# ADDENDUM

**ADDENDUM NO.:** 001  
**PROJECT NAME:** CANTY ELEMENTARY SCHOOL ANNEX  
**PROJECT NO.:** 05750  
**CONTRACT NO.:** C1568  
**DATE OF ISSUE:** May 28, 2015

## NOTICE OF CHANGES, MODIFICATIONS, OR CLARIFICATIONS TO CONTRACT DOCUMENTS

Sheet **M.201a**

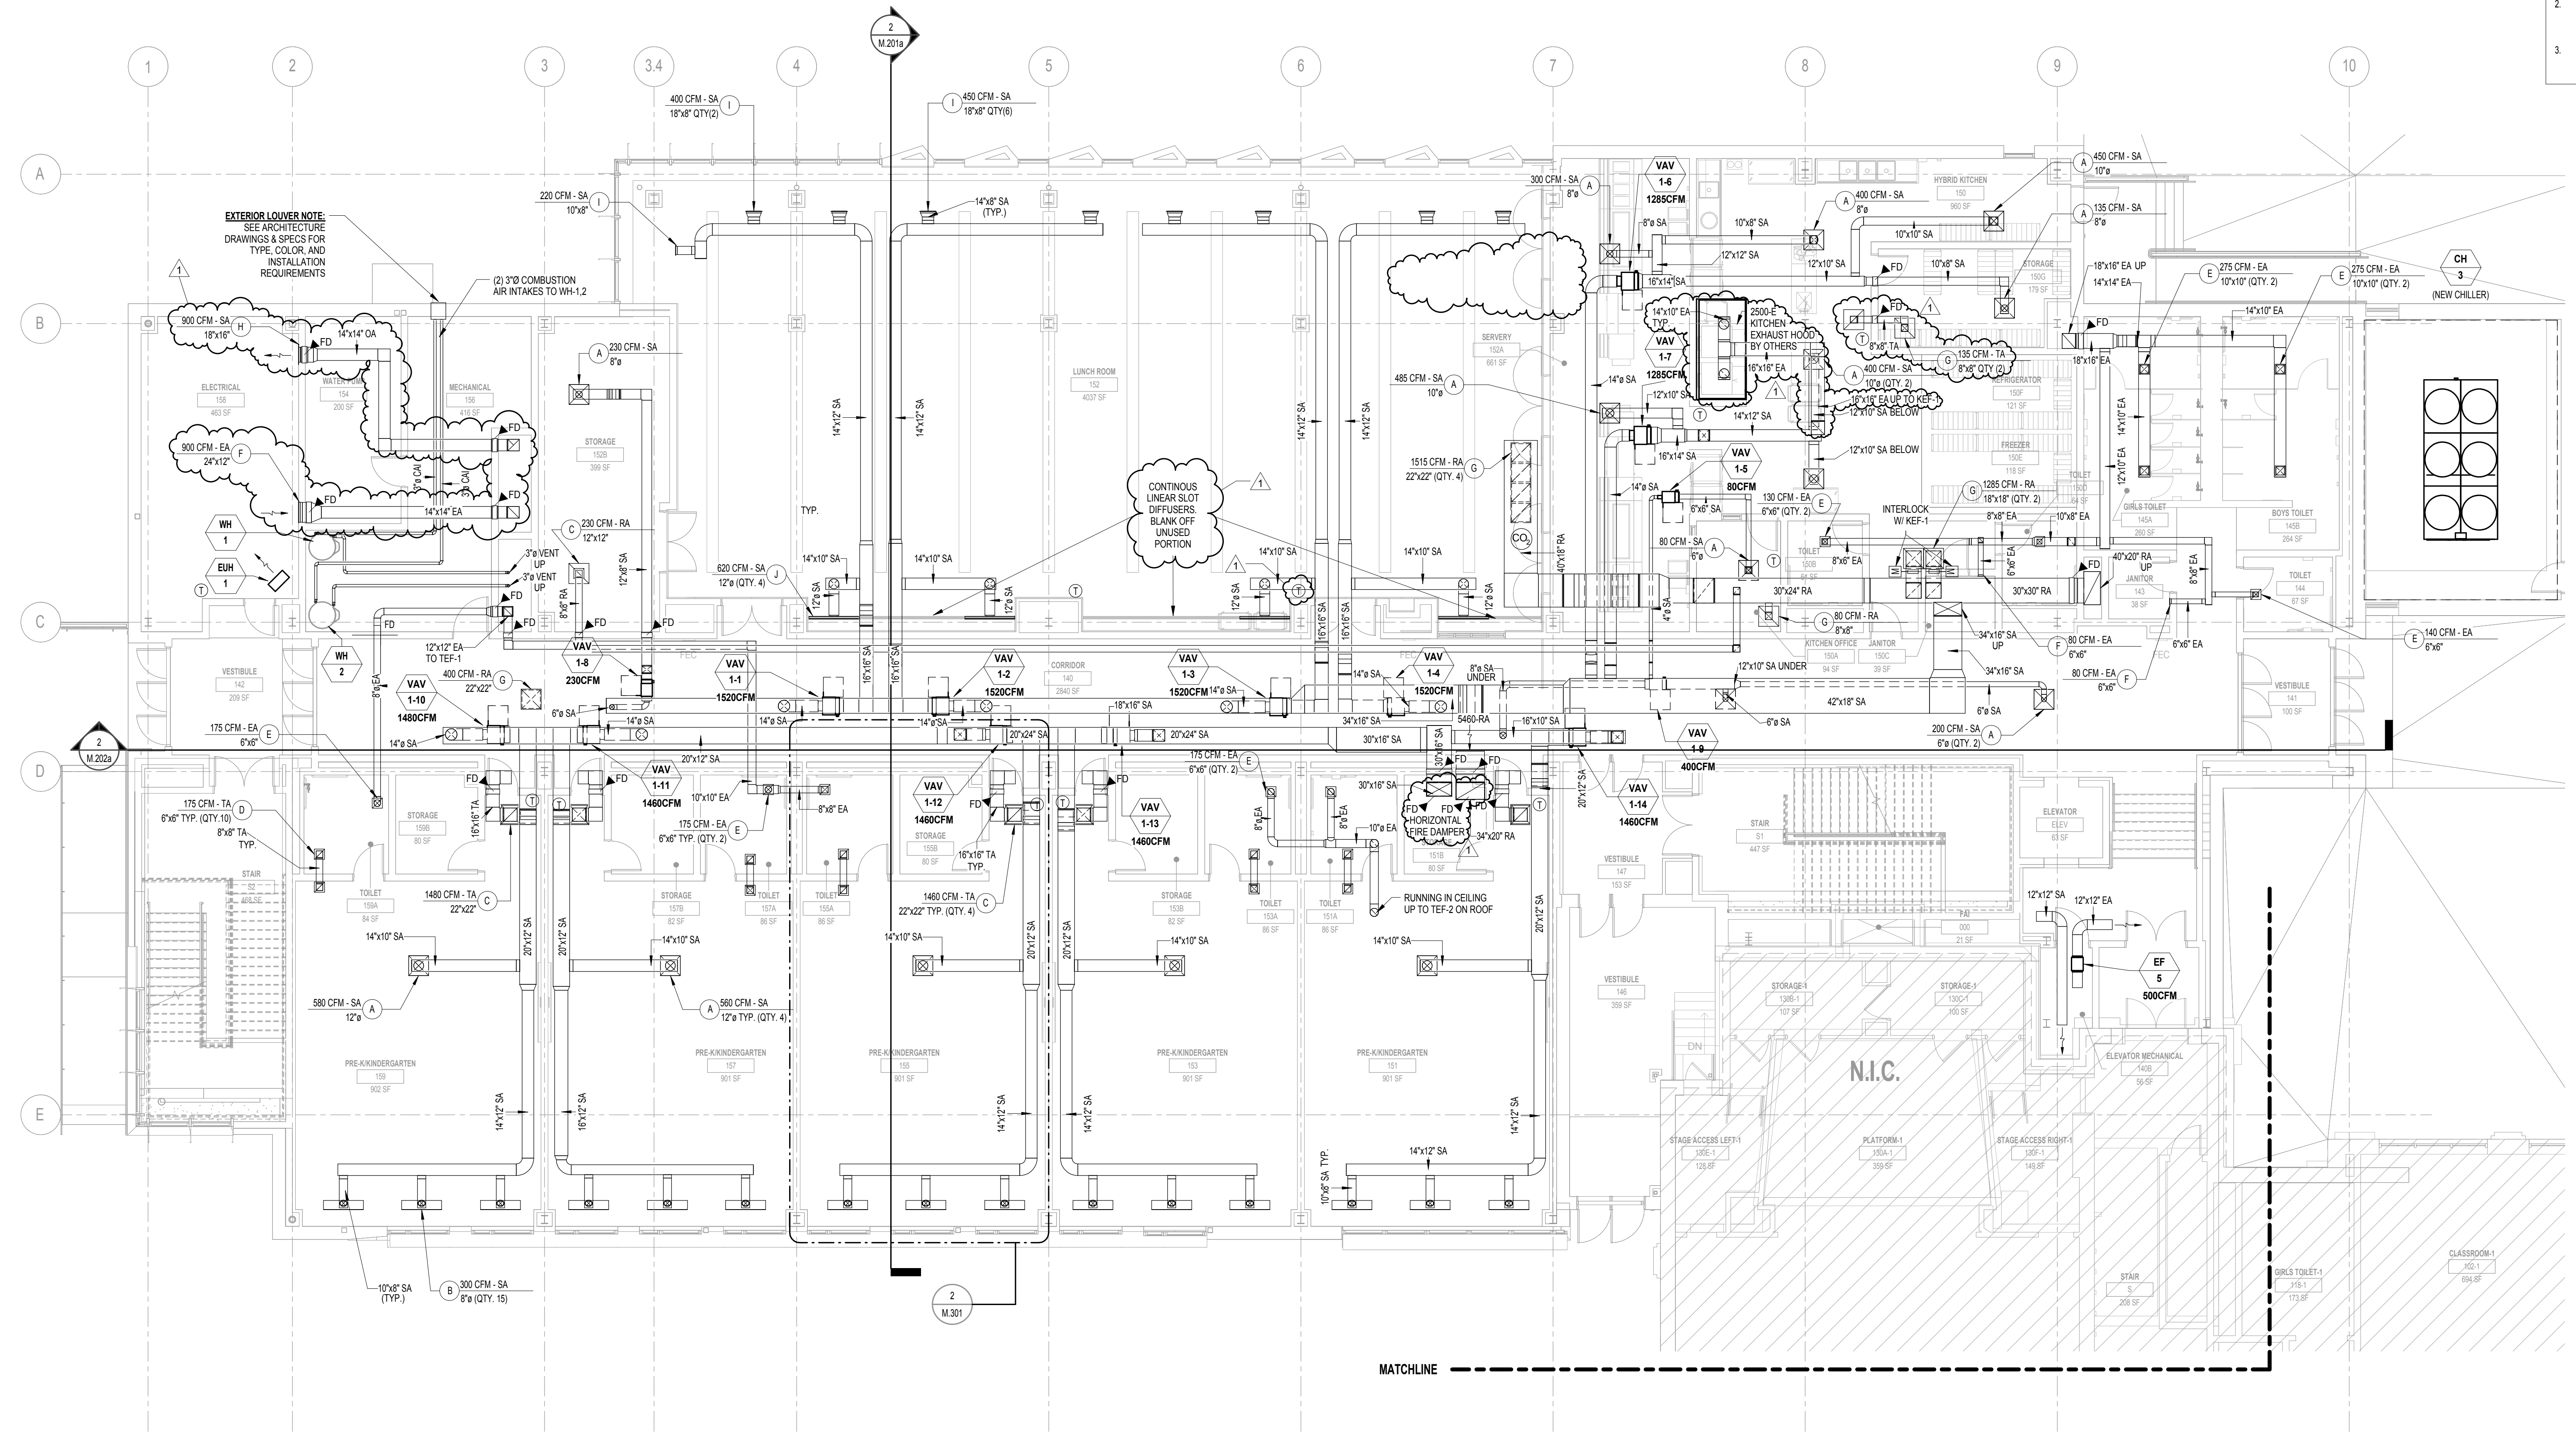
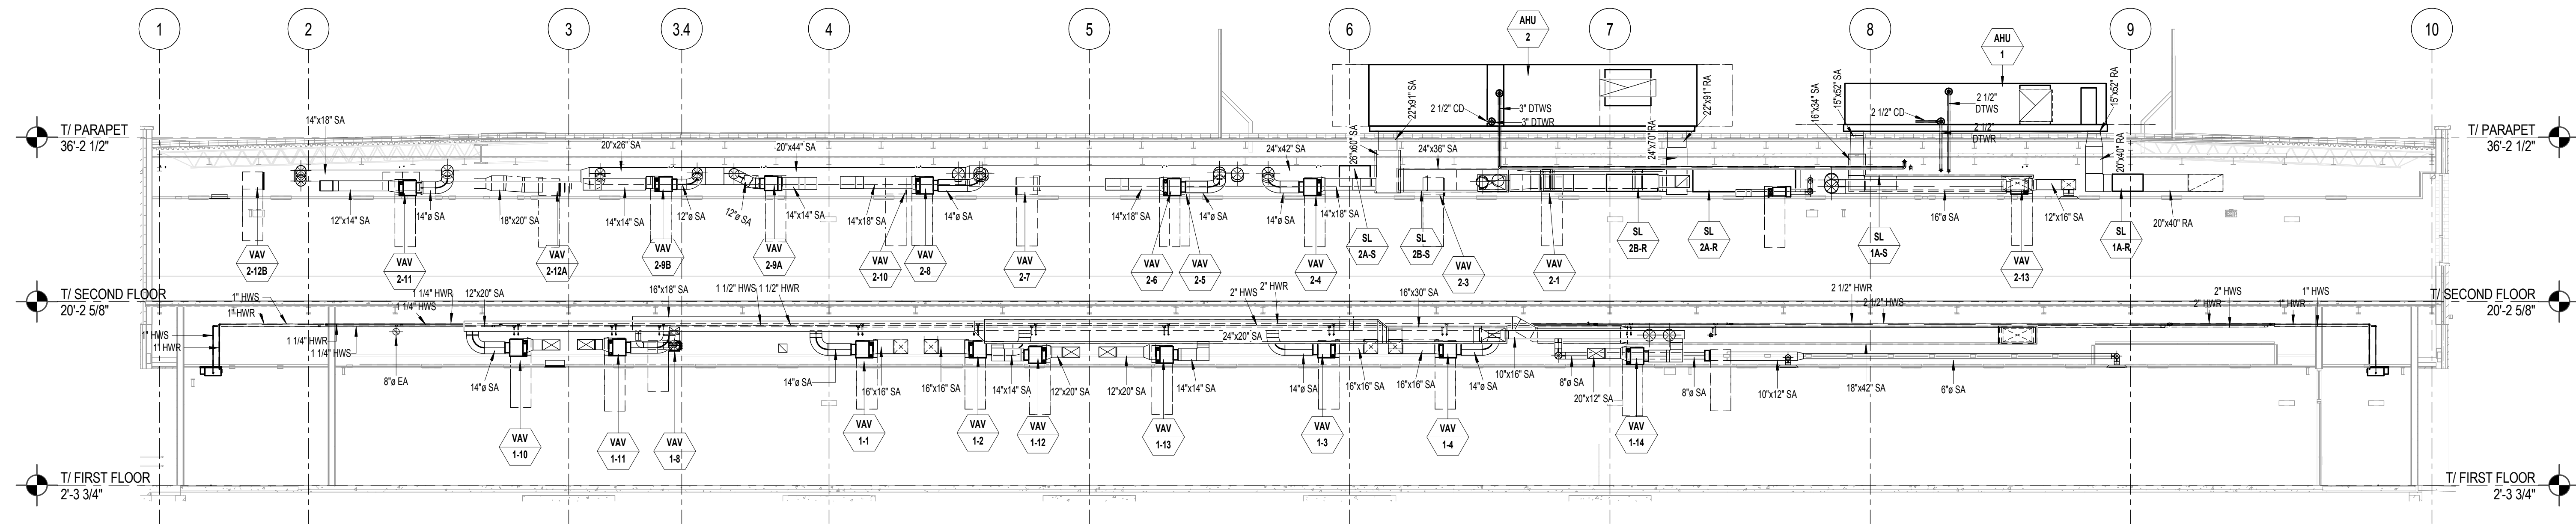
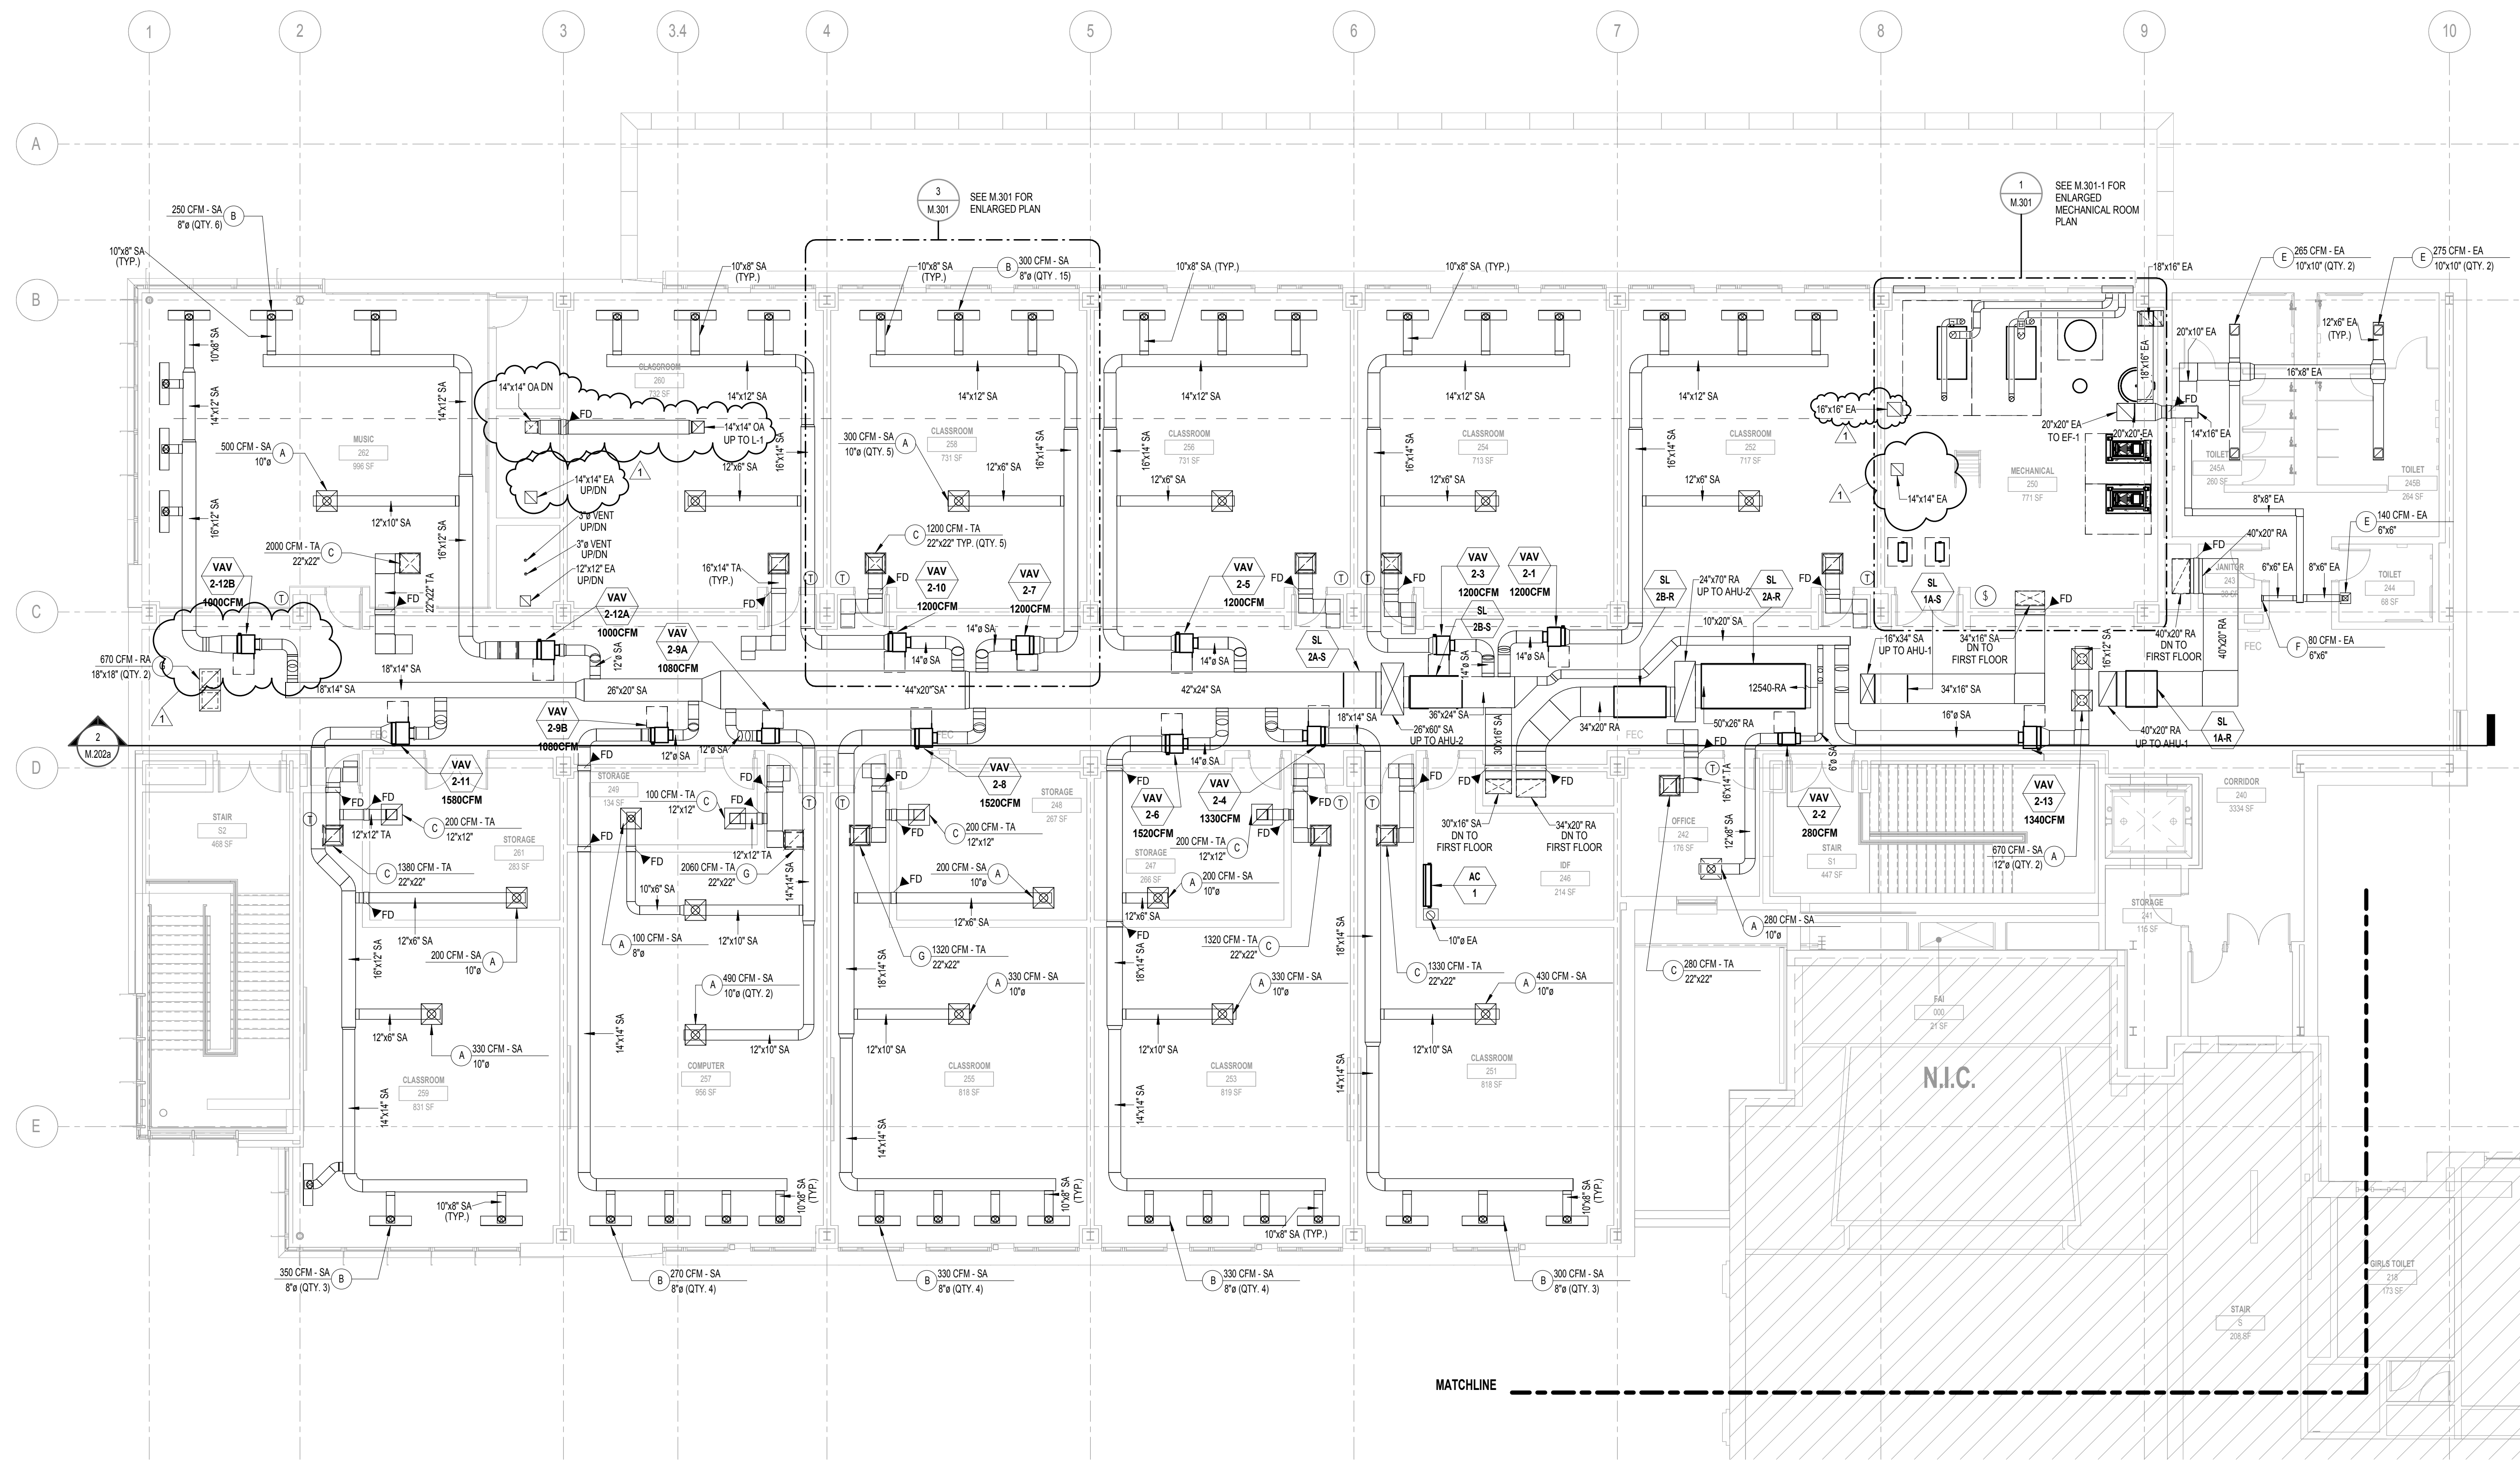
- b. Removed note 5 from City of Chicago Notes
- 11. Sheet M.201a First Floor Area A - Partial Mechanical Ductwork Plan
  - a. Revised transfer air ductwork for Storage 150G.

- b. Revised exhaust ductwork and outside air ductwork and grille sizes for electrical room 158
  - c. Note for linear slot diffusers in lunch room revised

- d. Horizontal fire damper has been added at the floor slab for both- SA and RA ductwork
  - e. Transfer air ductwork between lunchroom and server has been removed

- f. Kitchen exhaust hood has been revised to be 2500 CFM, and ductwork sizing has been updated for revised airflow.
- 12. Sheet M.202a Second Floor Area A - Partial Mechanical Ductwork Plan
